Re: Kaiser Tulsa Adjacent Land Remediation Modification of Approved Adjacent Land Remediation Plan

February 16, 2001  
Project No. 5427F-01

### Buried Spillway

FIGURE 1  
INTERPRETED SPILLWAY LOCATION

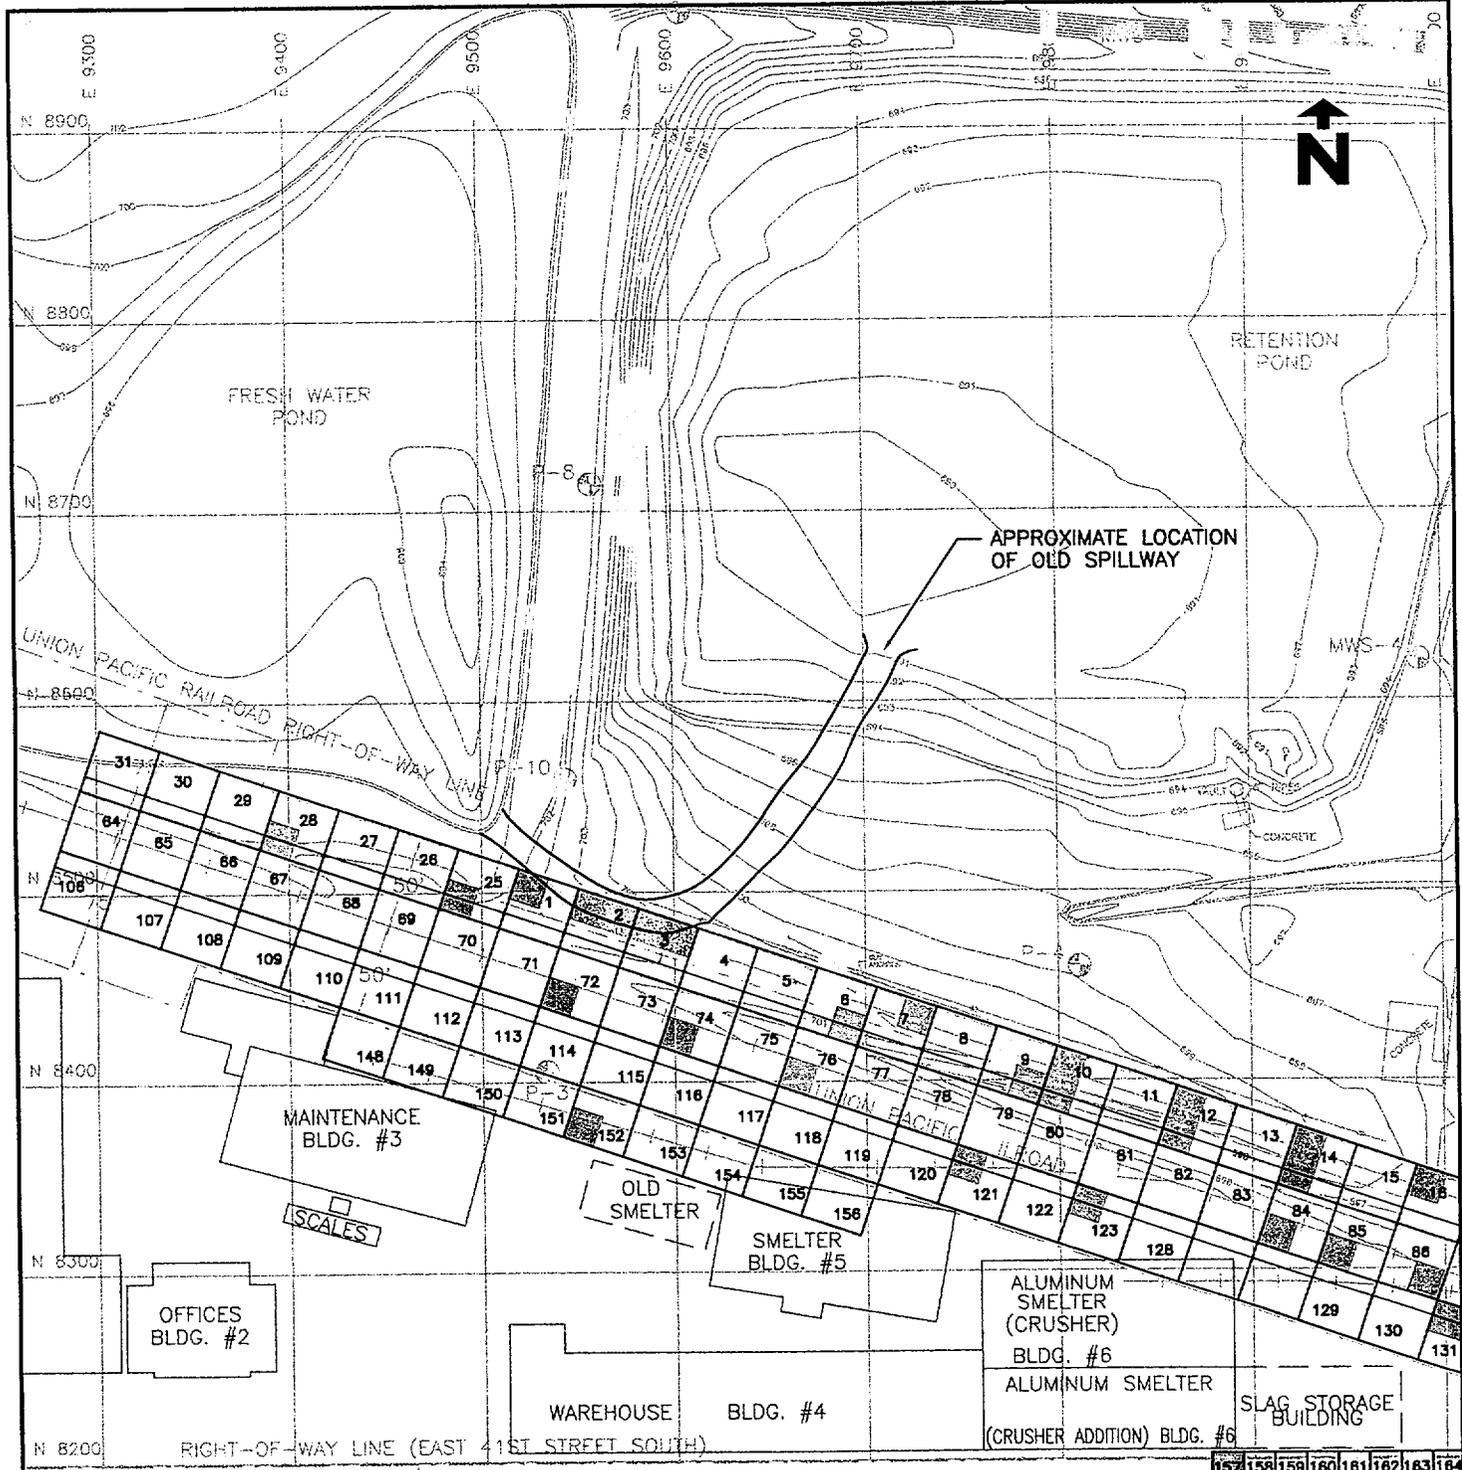
Earth Sciences Consultants, Inc.'s interpretation of the approximate location of the buried spillway was overlaid on the site characterization map. The area in question is shown in the enclosed Figure 1. As shown in this figure, the spillway lies primarily on Kaiser Aluminum & Chemical Corporation (Kaiser) property but does intersect adjacent area Grids 1, 2, 3, and 4.

As excavation continued in the area, reaching depths of approximately 20 feet, a severe water problem was encountered. The old spillway appears to be hydraulically connected to both the Fresh Water Pond and Retention Pond. At the working depth, large quantities of water from one or both of the ponds enter the excavation. This condition which severely impedes the remediation effort will be extremely difficult to control as long as the ponds contain water. Therefore, we recommend that excavation in the immediate area of the buried spillway be discontinued temporarily. This area can be addressed in the future as part of the on-site decommissioning project. The area is relatively small and proximate to the Kaiser property.

Specifically, we recommend that remediation proceed in the southern two quadrants of Characterization Grids 1 through 4. The remaining northern quadrants of Characterization Grids 1 through 4, which are located within the spillway, will be addressed during the on-site remediation activities. This approach is more realistic since water levels in the two on-site ponds may be lowered by closure of the Fresh Water Pond and/or other methods as part of the on-site decommissioning effort. We expect that this will alleviate the current difficulties associated with this area.

We will remediate the two southern quadrants of each of the Characterization Grids 1 through 4, up to and including the Sprint fiber-optic cable. Four soil samples will be collected in each of the grids. Two surface samples (one per quadrant) and two side wall samples (one per quadrant) will be obtained, where applicable. All final status surveys will be taken in accordance with the approved plan. Following remediation, the western, southern, and eastern walls of the survey unit will be lined with 60-mil high-density polyethylene liner, or equivalent, and backfilled to the specifications of the Adjacent Land Remediation Plan. This will allow release of the 25-foot strip along the railroad as well as clear the fiber-optic cable area. Concurrently, the spillway will be backfilled. Due to the depth and size of the hole, it should not be left open any longer than it needs to be.
